**TOWN OF NEWBURGH  
PLANNING BOARD  
TECHNICAL REVIEW COMMENTS**

**PROJECT: NEWBURGH PARK ASSOCIATES(NPA) SITE PLAN**  
**PROJECT NO.: 17-03**  
**PROJECT LOCATION: SECTION 89, BLOCK 1, LOT 19.22**  
**REVIEW DATE: 30 OCTOBER 2020**  
**MEETING DATE: 5 NOVEMBER 2020**  
**PROJECT REPRESENTATIVE: ZEN DESIGN CONSULTANT, INC.**

<b>ENGINEER</b> WILLIAM J. MORREAU 	<b>PROPOSED SITE PLAN</b> <b>NEWBURGH PARK ASSOCIATES, INC.</b> <b>PROPOSED SITE PLAN</b> SBL: 89-1-19.22 TOWN OF NEWBURGH, ORANGE COUNTY, NY	
	DATE 7/7/2016	SCALE 1"=30'
		SHEET NUMBER 2 OF 5

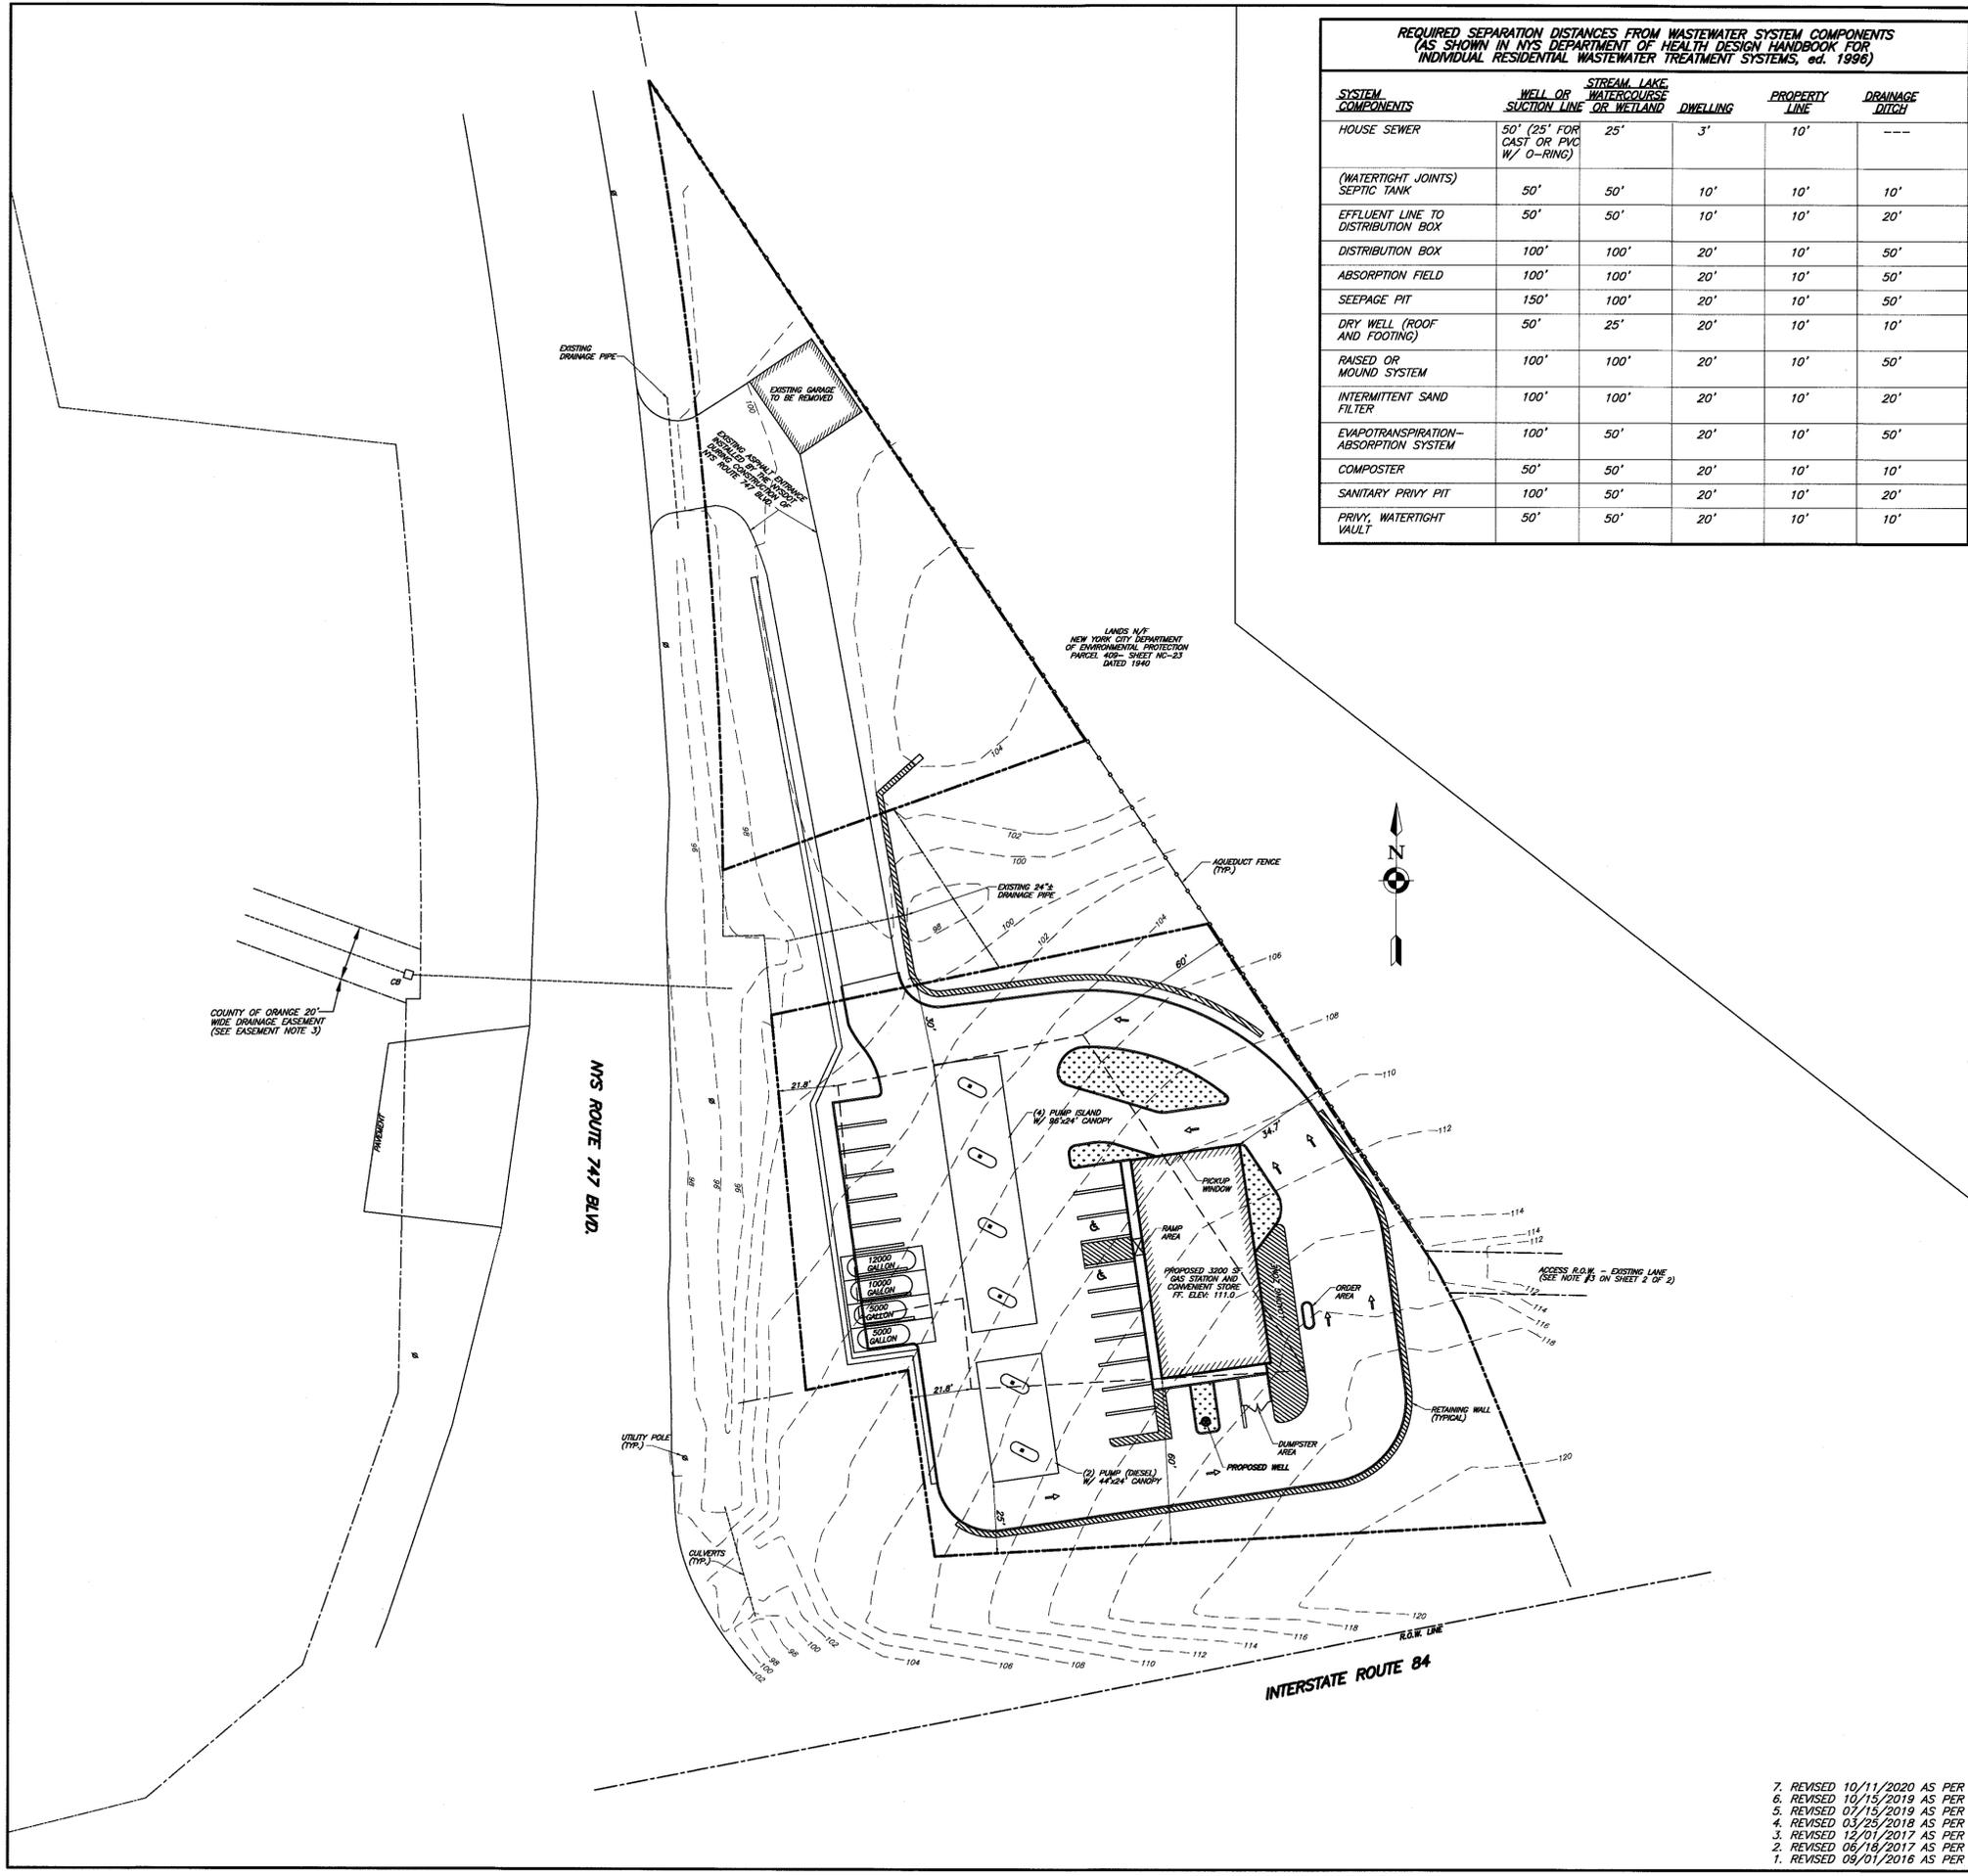
1. Revised plan shows a retaining wall crossing the parcel between the two parcels owned by the subject project.
2. Rims and inverts of all drainage pipes should be depicted including, the 24 inch drainage pipe, existing drainage pipe at the driveway access, and the drainage pipe crossing NYS Route 747.

3. Top of wall, base of wall elevations should be depicted at various locations along all proposed retaining walls.
4. The Zoning Bulk Table should be addressed where the 25 foot from NYS Route 84 is depicted. Did Variance also provide for the 25 foot front yard separation from the corner lot?

9. Notes pertaining to requiring design for all retaining walls proposed, stamped by a NYS Licensed Professional required at Building Permit.
10. The pick-up window area of the building does not appear to have a canopy or cover. This should be addressed.

11. Truck turning template for the fueling trucks should be identified on the site plan.
12. Future submissions should identify a site landscaping plan.

13. Guide rails should be identified on areas where retaining walls drop off to lower grades.
14. Plans should be submitted to the New York City Department of Environmental Protection for review as they are an adjoining land owner for the Catskill Aqueduct property.

15. A parking calculation should be identified on the plans in the Bulk Table.
16. The building will be required to be sprinklered. Provisions for a sprinkler system are required and or a waiver sought from the Building Department.

18. Signage on the site should be addressed in future submissions.
19. The survey identifies the southerly portion of the site abutting Interstate 84 however the site abuts the ramps for Interstate 84. The survey should be further detailed to show the location of the ramps and intersection with NYS Route 747. Pavement marking, striping and other NYSDOT details within 747 should be depicted on the plans.

20. Stormwater management facilities should be addressed on the site. The site would be considered a stormwater hotspot based on NYSDEC regulations for Service Stations.
